SOP 94-04

RETRIEVAL OF Cf NEUTRON SOURCES

SUBJECT: Recovery Plan for Californium-252 Radiography Sources from the Maneuverable Neutron Radiography System

SUBJECT: Recovery Plan for Maneuverable Neutron Radiography System Californium-252 Sources
(Your Memo, 5 May 94)

RADIOLOGICAL SURVEY 9424811

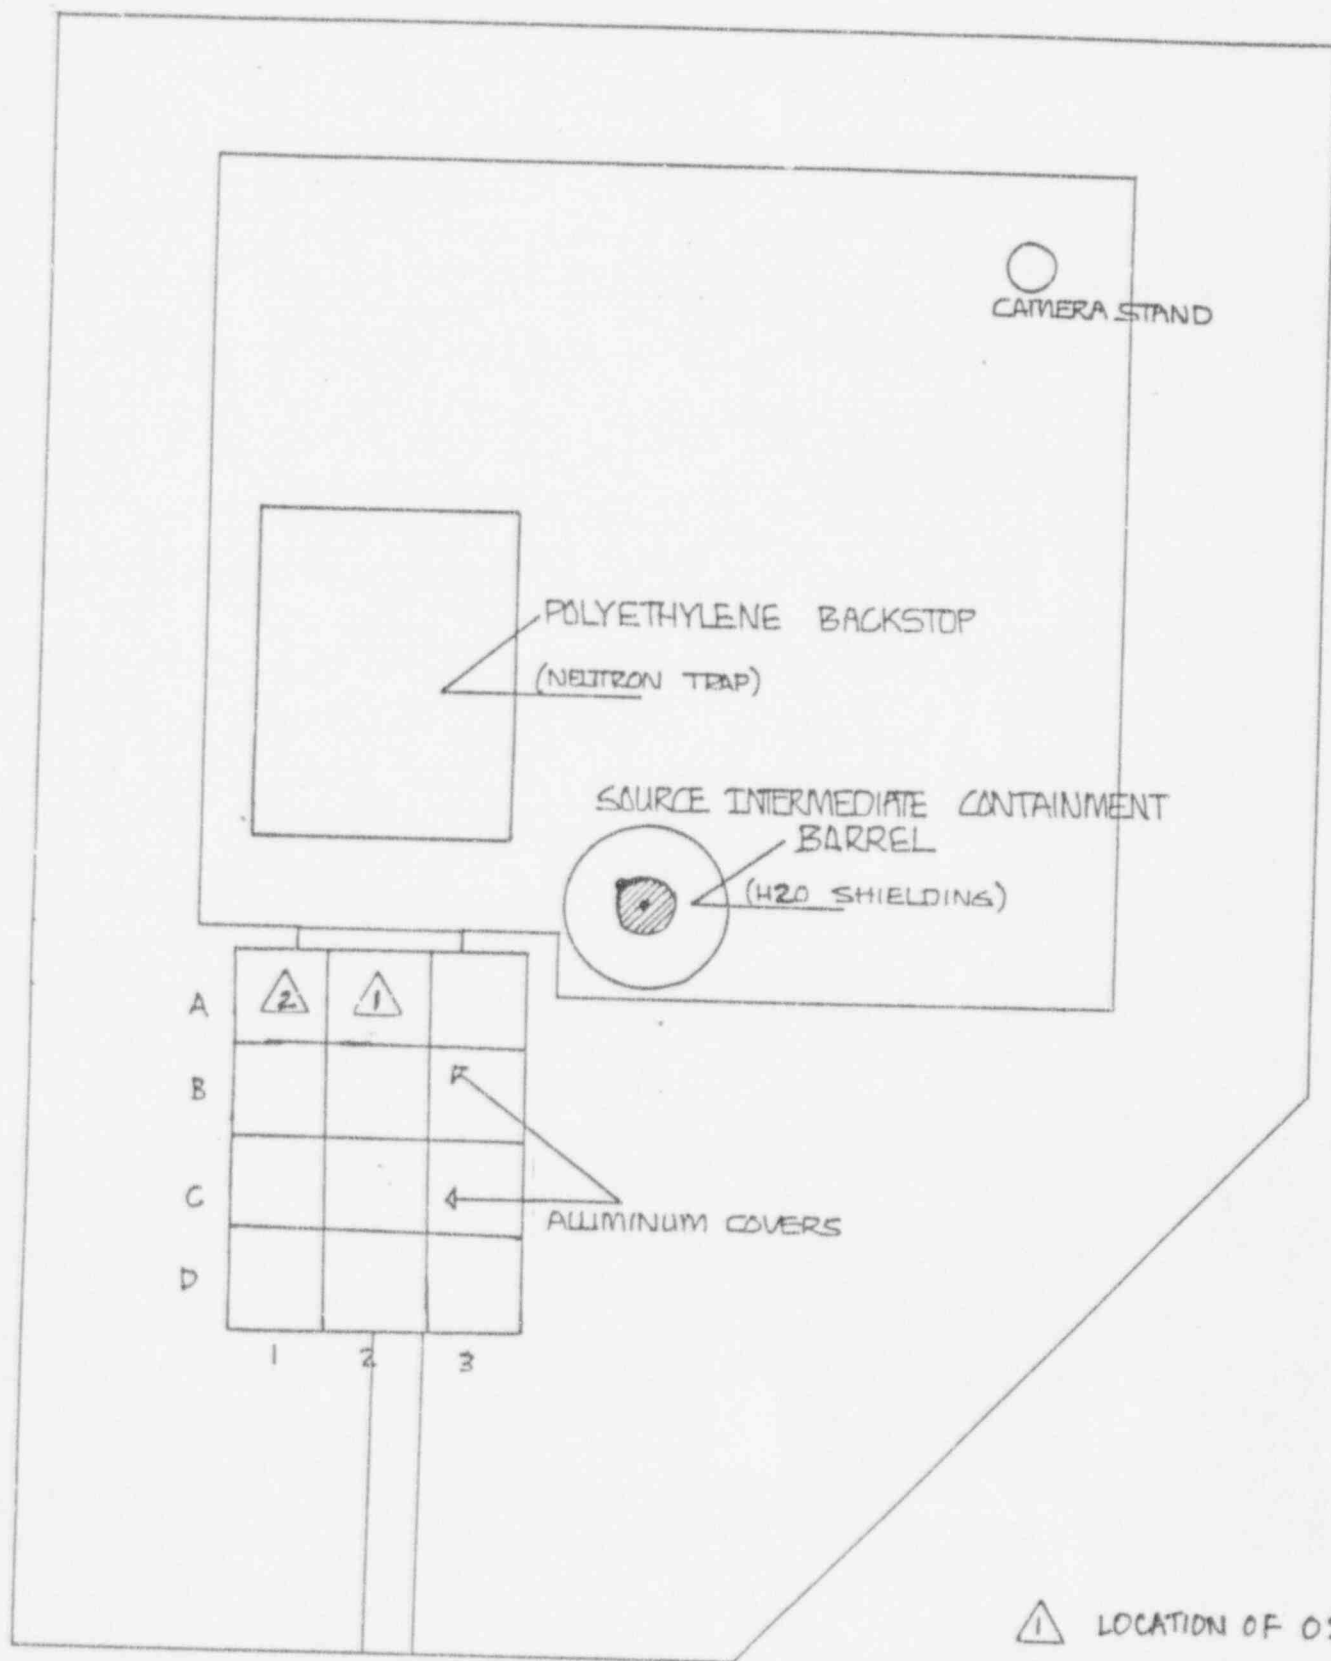
- e. Planned dose limits and the basis for calculating stay times. Estimated dose rates at key positions around the bunker and estimated total doses for the operators. If pocket dosimeters are to be used, then describe them and give their full scale range.

e. The planned dose limit for recovery personnel will be 500 millirem. The basis for calculating stay times will be actual radiation surveys (see Attachment 1). The actual dose rates at key positions (see Attachment 2) can be determined from Attachment 1. The highest total dose for the operators is estimated to be 165 millirem (based on 15 minutes in the highest expected radiation field). Dosimeter Corporation Model 862 pocket dosimeters (range 0-200 milliroentgens) will be used during the operation.

f. A grid survey has been performed prior to the operation (see Attachment 1). Both neutron and gamma radiation surveys will be performed on top of the bunker by the HPT (see Attachment 2) during the recovery operation. Upon completion of the transfer from the source intermediate containment barrel to the bunker storage tube radiation surveys will be conducted around the entire circumference of the bunker. All radiological surveys will be performed by HPTs. If radiation levels exceed 1000 millirem per hour (steady state) during the recovery phase, personnel will stop work and immediately evacuate the area.

RECOVERY PHASE

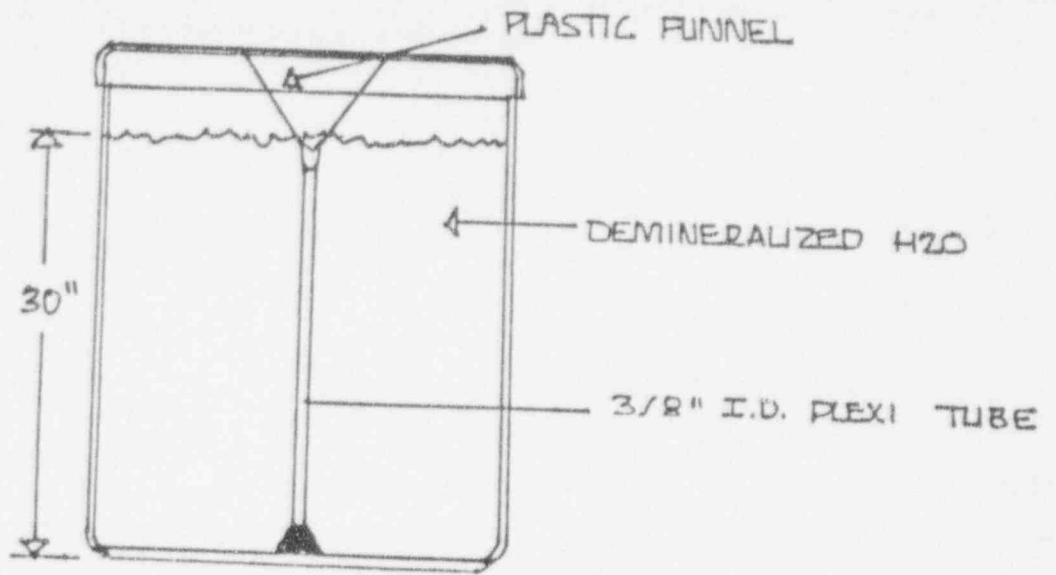
- g. Diagrams of the equipment described in your recovery procedures and floor plans of the locations of the recovery team.

- g. Attachment 2 is a diagram showing the locations of the recovery team members. Attachment 3 is a sketch of equipment described in the recovery procedure.
 - h. A written report will be issued to the RIC upon completion of the dry-run training.
3. For further information, contact Jeff Ching, TIRH, at DSN 633-1023.
